The contact spring on FEU finger grip carrier and FEU (Grip) carrier for 6.3x32mm fuse is improved.

Product Change Notification					FEU fingergrip improvement		
owner	creation date	release date	released by	change order no	rev	page	D10-016-241
dislercy	08.06.2017	21.12.2017	haeckima	2013038	A	1 of 1

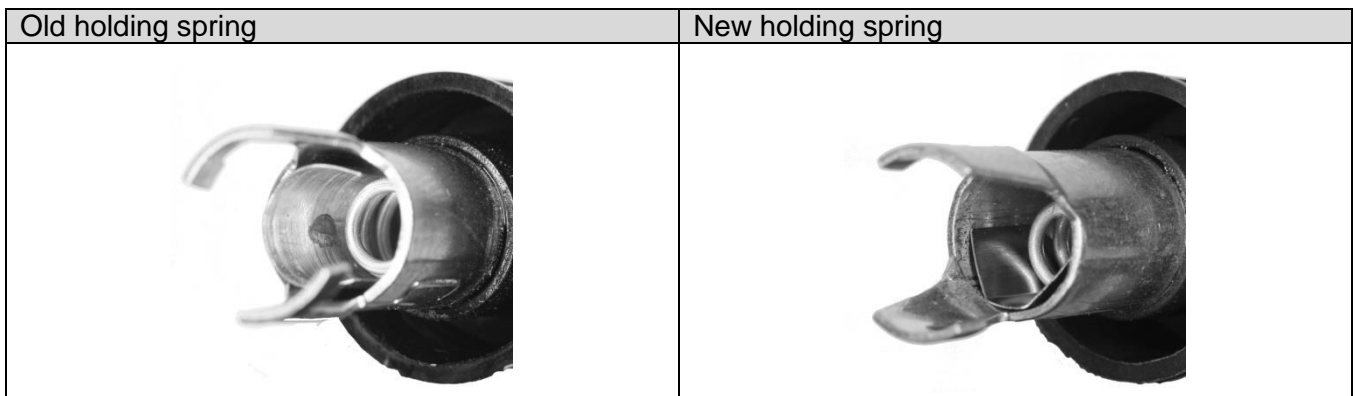
Form	Yes	Contact spring of fuse carrier changed
Fit	No	No change for dimension
Function	No	No functional change
Production Site	No	No change of the production site
Product Label	No	No label on the change
Packaging	No	No change in packaging
